TO: M. JAWORSKI, S. GERHARDT

FROM: M.L. REINKE

SUBJECT: MODIFICATION OF HEAT FLUX REQUIREMENTS FOR OBD R3 & R4 TILES

Figure 1: Equilibrium which drives OBD-R4 requirement for CASE#1 and the heat flux profile modeling (right). The green-dashed line is the time-averaged heat flux, assuming fast sweeping, while the red is the peak encountered over the scan.

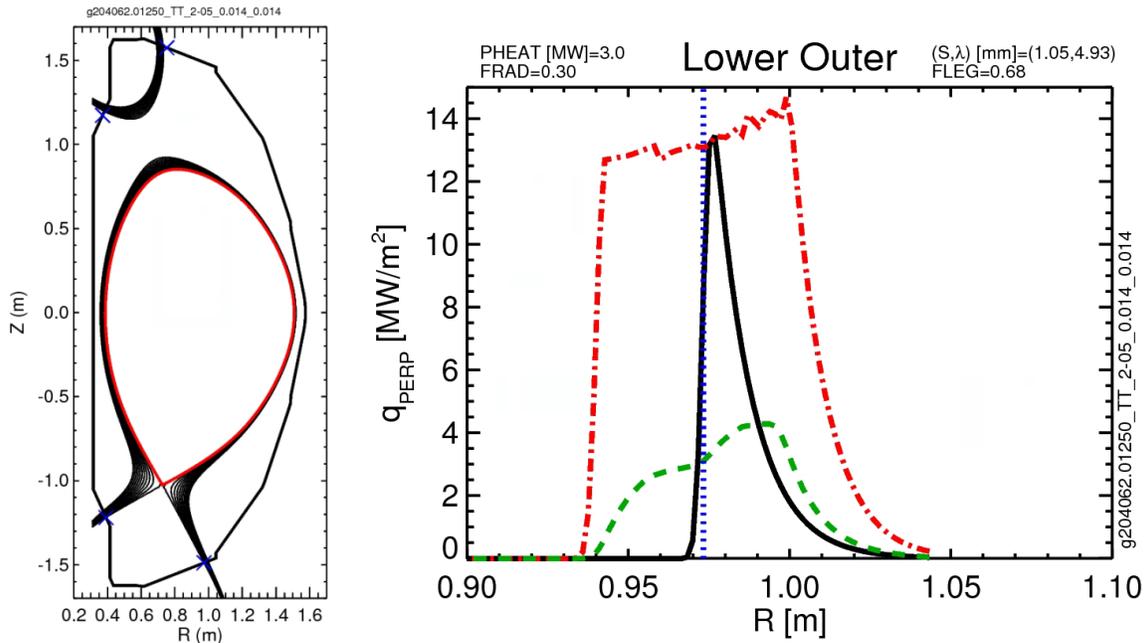
Examining PFCR-MEMO-008 [2] in more detail reveals the origin of the SRD requirement for OBD-R4 (CASE#1 through CASE#3). These are lower single null L-mode cases which create high heat flux due to weak flux expansion, despite limited input power. The most challenging requirement is CASE#1 which requests OBD-R4 sustain 4.3 MW/m^2 for 2 seconds. This is from the TT_2-05b case in Table 4.2.4 in [2], which is an L-mode plasma with 3 MW of input power.

Assuming 30% radiation and 70% going to the outer divertor, this is a total of 1.47 MW of power. The area of the OBD-R4 region is computed from a conical surface from (R,Z)=(96.65,149 cm) to (107.96,144.75), leading to a surface area of 0.773 m^2 . Note that adding up the x48 over and x48 under tile front surface

areas from the prior NSTX/NSTX-U beveled design estimate gives 0.666 m^2 . Neither of these accounts for tile gaps. If 4.3 MW/m^2 is assumed to be uniformly deposited on the swept conical R4 surface, then the total power deposited is 3.32 MW, over estimating the power input by roughly a factor of two. This is consistent with inspection of Figure 1, as the heat flux of 4.3 MW/m^2 describes the 'peak' which is not evenly distributed over the 11-12 cm length of the R4 surface. Adding an 'Extent' of 11 cm to Table 4.4-3 in [1] for CASE#1, CASE#2 and CASE#3 would improve agreement (Recommendation A).

- A. Adjust the OBD R4/5 heat flux requirement for CASE #1, #2 and #3 in Table 4.4-3 of [1] to add an Extent of 11 cm. This will have the effect of reducing the net energy input into the tile rows, bringing it more in line with the estimate from power balance.
- B. Remove the OBD R4/5 CASE #4 requirement in Table 4.4-3 of [1]. Scrutiny of scenarios shows driving scenarios will not place the strike point on R4.
- C. Adjust the OBD R3 heat flux requirement for CASE #1 in Table 4.4-2 of [1] to add an Extent of 11 cm. This will have the effect of reducing the net energy input into the tile row, bringing it more in line with the estimate from power balance.

Figure 2: Equilibrium which drives OBD-R3 requirement for CASE#1 and the heat flux profile modeling (right). The green-dashed line is the time-averaged heat flux, assuming fast sweeping, while the red is the peak encountered over the scan

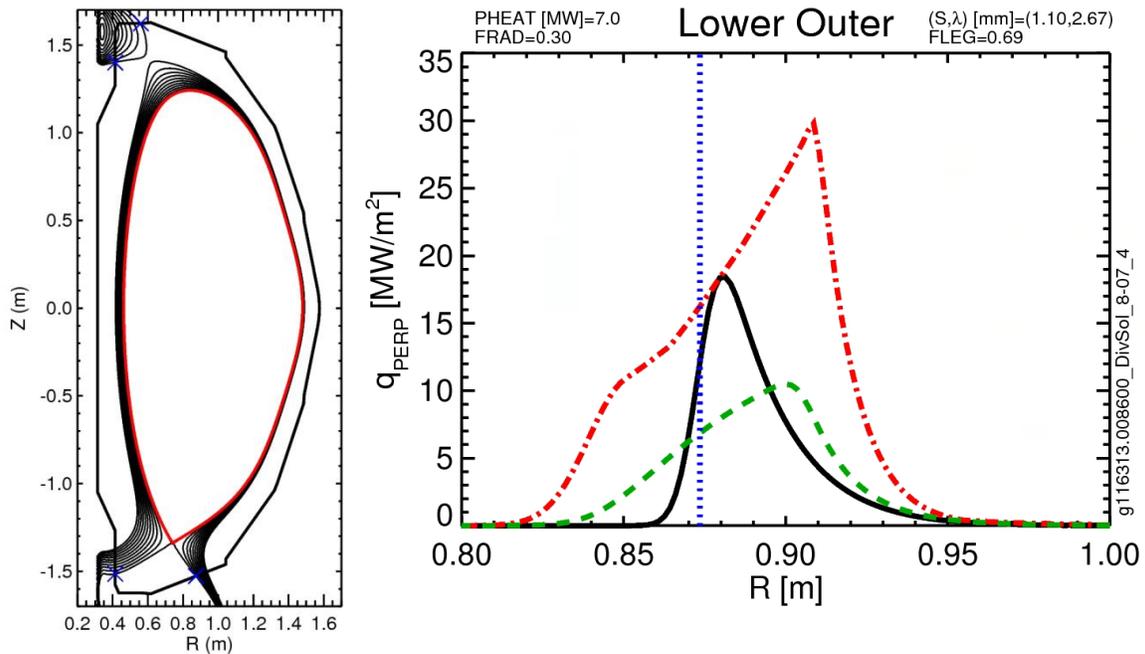
Examining [2] for what drives the SRD requirement for OBD-R4, CASE#1, the use is much different than R4. As outlined in Section 7, the R3 tile is meant to support low-triangularity H-mode research and as such has much higher input power than for OBD-R4. In fact, many DivSOL and PED requests have heat flux

that exceed CASE#1, but are declared to be to challenging without additional radiative exhaust or further confirmation of the heat flux width scaling. This means the physics program would benefit from an OBD-R3 which can exceed the given requirements.

Following the same analysis as above, the swept surface area of the R3 tiles is computed from $(R,Z)=(84.9,153.7)$ to $(96.4, 149.1)$ cm results in an area of 0.705 m^2 . The CASE#1 has 7 MW of input power, resulting in 3.43 MW of power going to the outer divertor. The requirement for 10.5 MW/m^2 applied uniformly over the tile would lead to 7.4 MW of power going into the PFC. Once again this is approximately twice the power that is being delivered and adding an 'Extent' to the heat flux requirement of 11 cm would bring the power delivered closer in line to the underlying scenario and bring the heat flux profile closer to matching what is shown in Figure 2 (Recommendation C).

The CASE#2 requirement should remain as-is. While the 3.0 MW/m^2 of power over the tile surface also implies an excess power to the tile region as compared to the scenario (MPFC 3-02 would have 0.98 MW of power to the OBD), the low-power, long pulse scenarios for the OBD-R3 were not thoroughly investigated in [2]. Maintaining a 3.0 MW/m^2 for 5 sec requirement will ensure operational flexibility and presently is not expected to be a challenge for t-bar based PFCs.
